SYNGENE INTERNATIONAL LTD, VELANKANI TECH PARK, ACCESSIBILITY AUDIT REPORT

PREPARED BY SVADHIN SOLUTIONS

GROUND FLOOR, SYNGENE INTERNATIONAL, VTPL – ACCESSIBILITY OVERVIEW

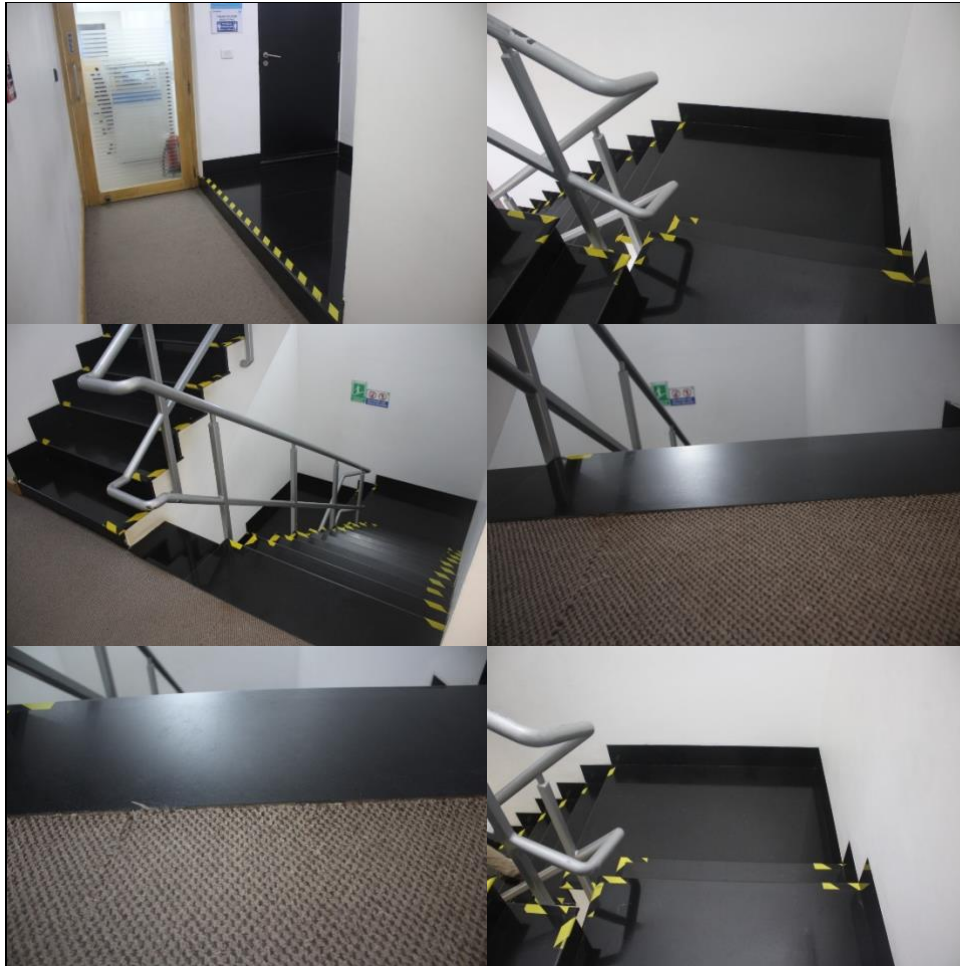
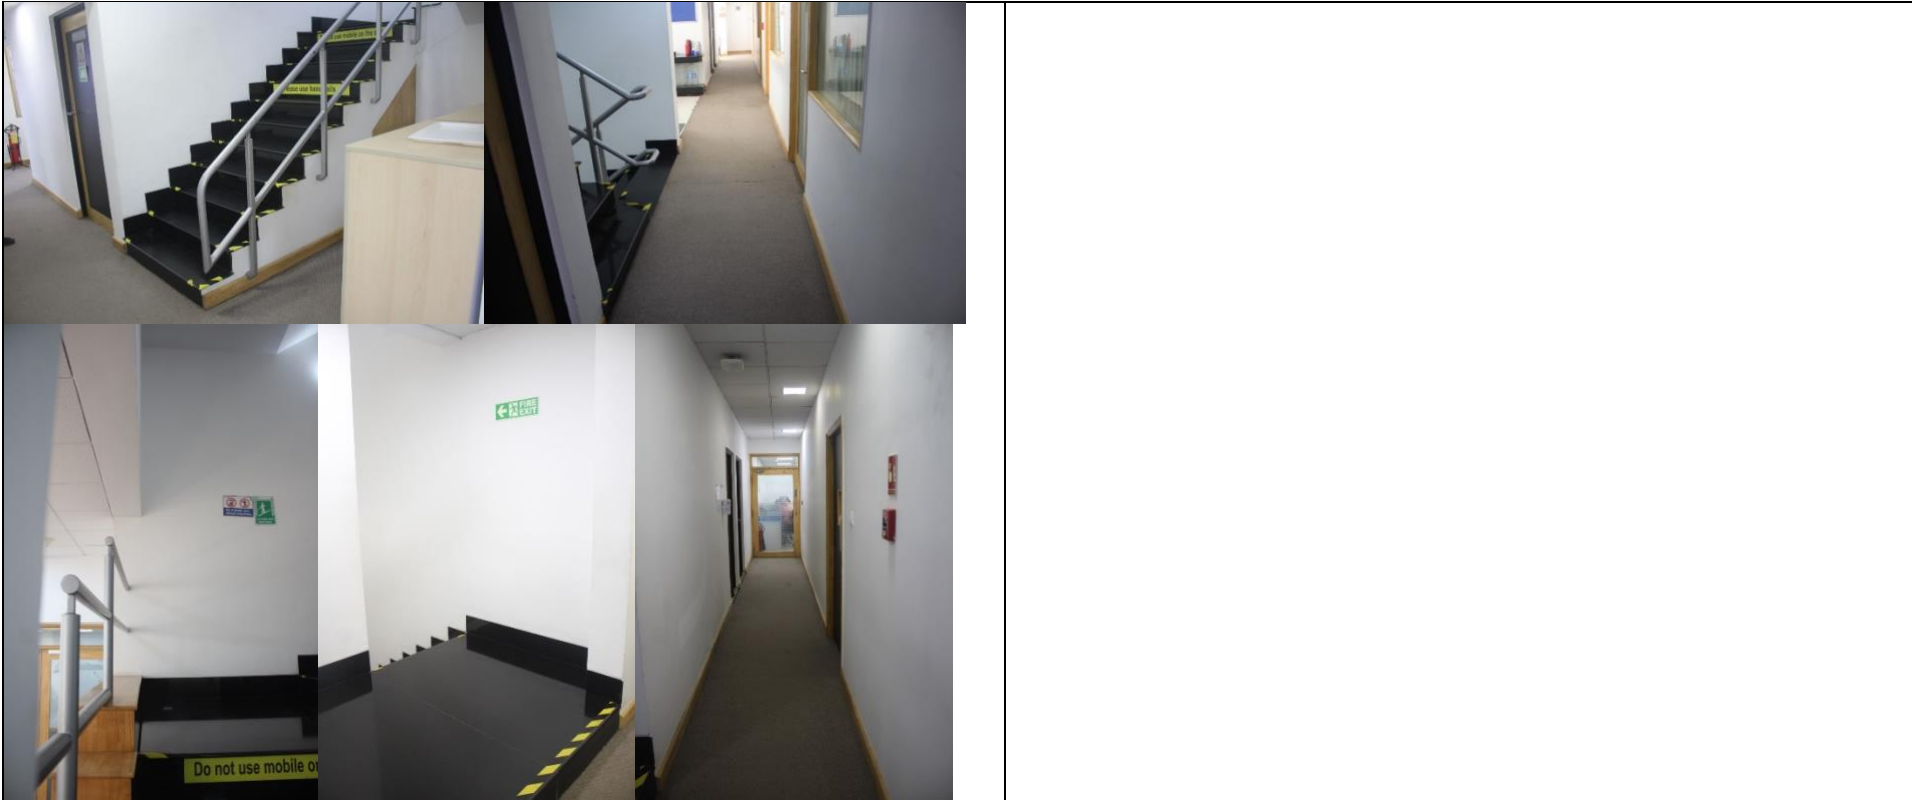
- The front staircase handrails on the left side below the beam for the flight that is coming into the landing areas have inaccessible clearance from handrail to the beam making this part of the handrails possibly unsafe for certain PwDs and the head clearance non-compliant

- All the steps in both the staircases have non-compliant colour markings and there are no antiskid provisions for all the step treads making both the staircases non-compliant and unsafe for PwDs
- Access to the front staircase from the third floor office entry has steps to access the staircase which don't have handrails and are missing anti-skid provisions for the step treads making them non-compliant
- The back staircase entry from the floor landings have small level differences because of the improperly flushed carpeted floors at certain points which may be unsafe for certain PwDs
